**CITY OF COCONUT CREEK**

### DEVELOPMENT REVIEW COMMITTEE (DRC) REVIEW #1 – NOVEMBER 13, 2024

<b>PROJECT NAME:</b>	Fifth Third Bank		
<b>PROJECT NUMBER:</b>	PZ-24090007		
<b>LOCATION:</b>	4805 Coconut Creek Parkway		
<b>APPLICANT/AGENT:</b>	BDG Architects		
<b>REVIEW/APPLICATION:</b>	Site Plan		
DISCIPLINE	REVIEWER	EMAIL	TELEPHONE
DRC Chair Urban Design & Development	Liz Aguiar – Assistant Director Sustainable Development	<a href="mailto:laguiar@coconutcreek.net">laguiar@coconutcreek.net</a>	(954) 973-6756
Sustainability, Urban Design & Photometrics	Linda Whitman – Sustainability Manager	<a href="mailto:lwhitman@coconutcreek.net">lwhitman@coconutcreek.net</a>	(954) 973-6756
Urban Design & Signage	Natacha Josiah - Planner	<a href="mailto:njosiah@coconutcreek.net">njosiah@coconutcreek.net</a>	(954) 973-6756
Transportation	Michael Righetti - Senior Project Manager	<a href="mailto:mrighetti@coconutcreek.net">mrighetti@coconutcreek.net</a>	(954) 973-6756
Building	Sean Flanagan – Chief Building Official	<a href="mailto:sflanagan@coconutcreek.net">sflanagan@coconutcreek.net</a>	(954) 973-6750

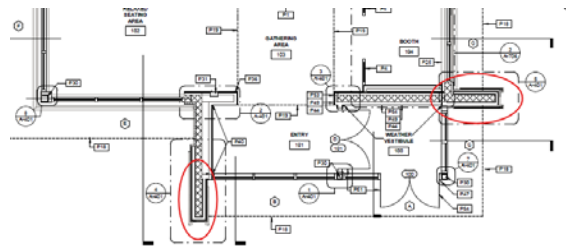
6. Be advised that the site lighting will be measured in the field using a light meter to ensure that the 10 fc limit is not exceeded. The building C.O. is predicated on meeting this requirement.

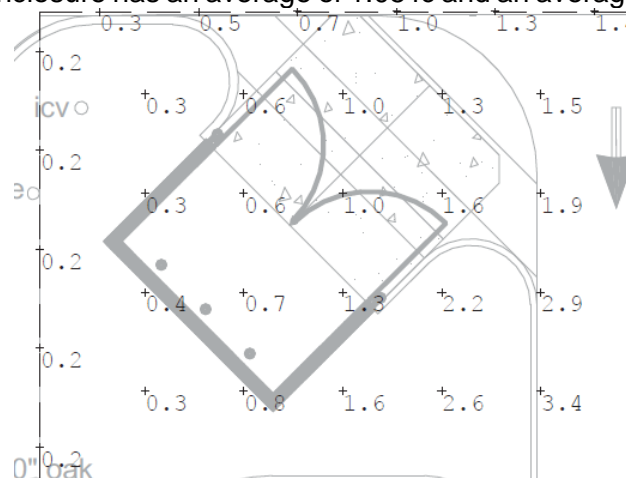
7. Trash enclosures by design are obstructed from casual viewing. As such, they do offer the opportunity to be used as an area of concealment by an abnormal user. Measures should be taken to reduce the desirability of the enclosure to be used for this purpose.
  - o Recommend adding convex mirrors to the rear of trash enclosure to allow a view inside of the enclosure prior to opening the swing gate.
  - o Per IES security lighting guidelines, recommend that trash enclosure be illuminated to an average of 3 fc with an average to minimum ratio of no more than 4:1. Currently, based on readings below, enclosure has an average of 1.05 fc and an average to minimum ratio of 5.25:1.
